HYUNDAI NEW THINKING. NEW POSSIBILITIES. Technical Service Bulletin	GROUP Driveshaft and Axle	NUMBER 12-DS-002
	DATE MAY 2012	MODEL(S) CM Santa Fe EN Veracruz
SUBJECT: SANTA FE (CM), VERACRUZ (EN) DRIVE SHAFT NOISE

Description: Some customers may report a slight creak or popping noise from the front of the vehicle when accelerating from a stop, either forwards or reverse. This bulletin describes the service procedure to replace the drive shaft washers with revised washers.

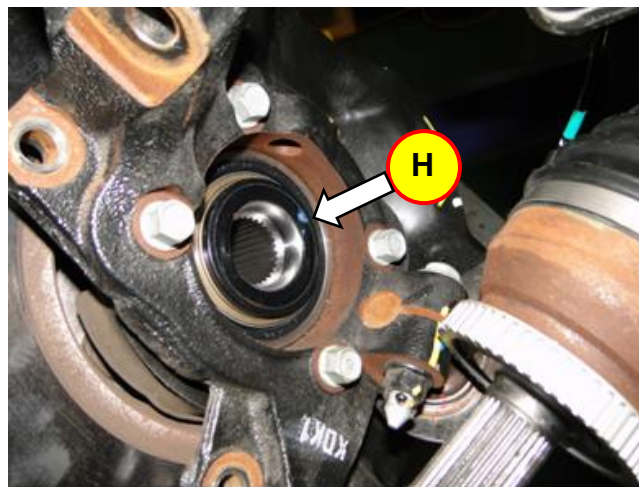
8. Remove and discard the plastic washer (H) from the front axle hub.

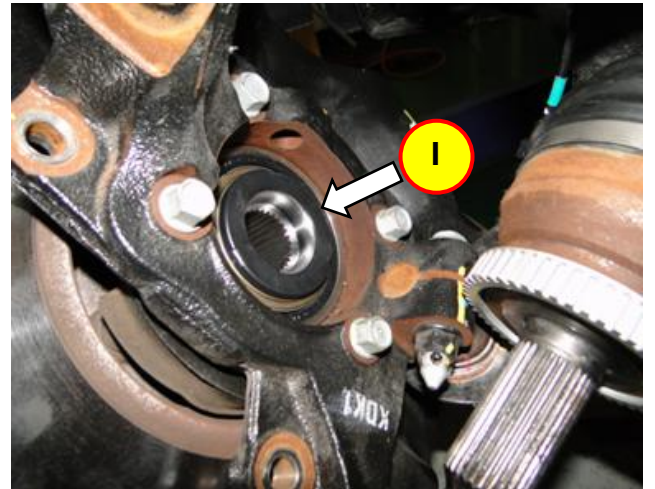
Washer has been removed from the axle hub.

9. Install the replacement drive shaft washer (I).
